Access Compliance Report Public Rights-of-Way (Curb Ramps)

Main Street: YORBA_ST		Cross Street: RAINIER_DR		Location:	SW
ADA ID: RPRK211006151313	Ramp Type: Type 7 - Directional 2	Initial Pass/Fail: Fail	Overall Compliance: No	Severity Score:	15
Codes/Mitigation Info/Possible Solution			Field Measurements/Component Compliance

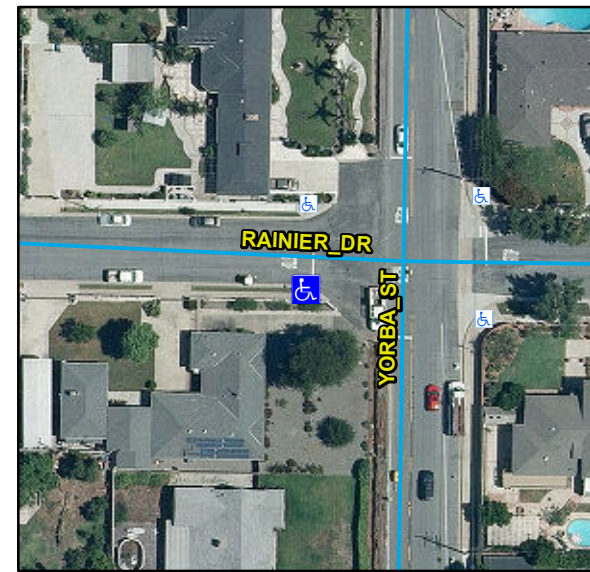
Remove & Replace Entire Ramp. Grind Gutter Lip.

R204.3, R304.2.2, R302.7.2, STD 1115
